HISTORIC AND DESIGN REVIEW COMMISSION

May 16, 2018

HDRC CASE NO: 2018-212
ADDRESS: 616 NOLAN
LEGAL DESCRIPTION: NCB 561 BLK 1 LOT E 50 FT OF 4
ZONING: R-6, H
CITY COUNCIL DIST.: 2
DISTRICT: Dignowity Hill Historic District
APPLICANT: Emilio Ruvalcaba
OWNER: Emilio Ruvalcaba
TYPE OF WORK: Front porch modifications and widening of front walkway
APPLICATION RECEIVED: April 24, 2018
60-DAY REVIEW: June 23, 2018
REQUEST:

**PLOT PLAN
FOR BUILDING PERMITS**

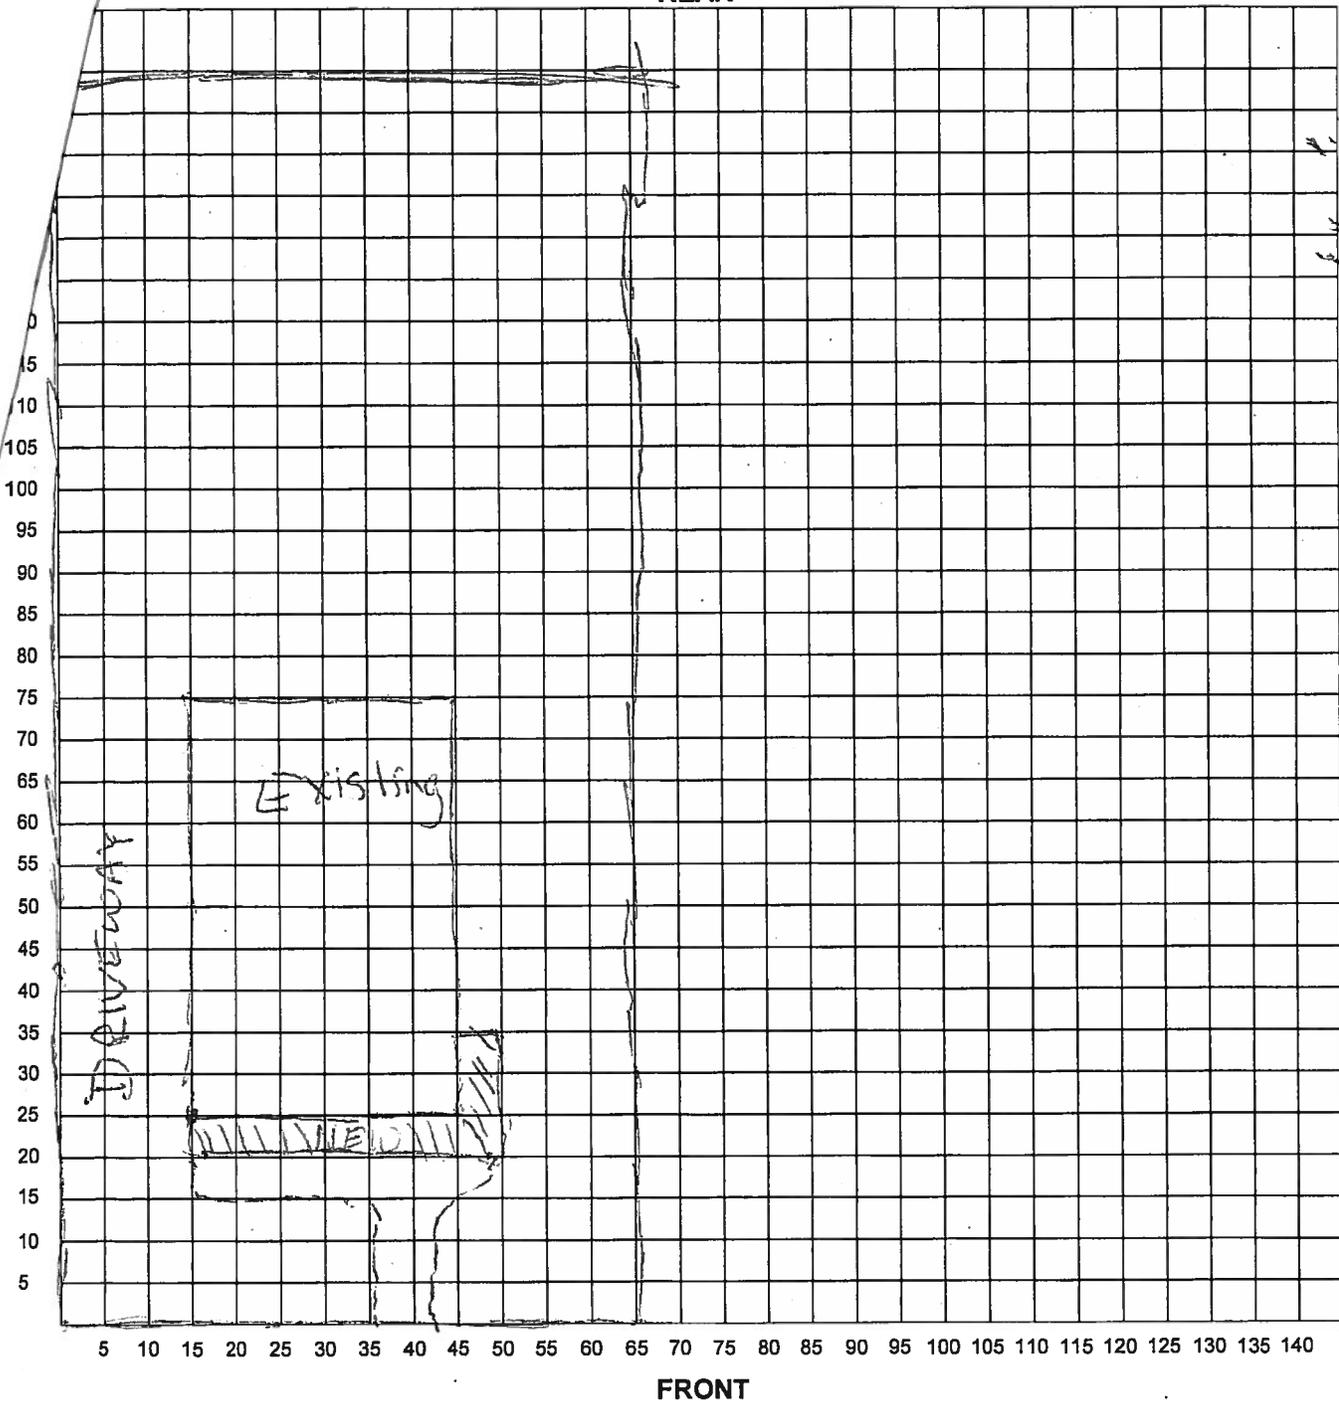
- d. WALKWAY – The applicant has proposed to modify the existing concrete walkway width from the three feet in width to five feet in width that expands to approximately ten feet in width as it approaches the front porch. The Guidelines for Sidewalks and Walkways 5.A.iii note that alterations to width and alignment should only be considered to preserve a historic tree. Staff finds that the proposal is inconsistent with the Guidelines and the walkway should be returned to its original configuration.

Staff does not recommend approval of the modifications to the front porch, steps, and walkway. Staff recommends that the applicant return the features to their original material and form.
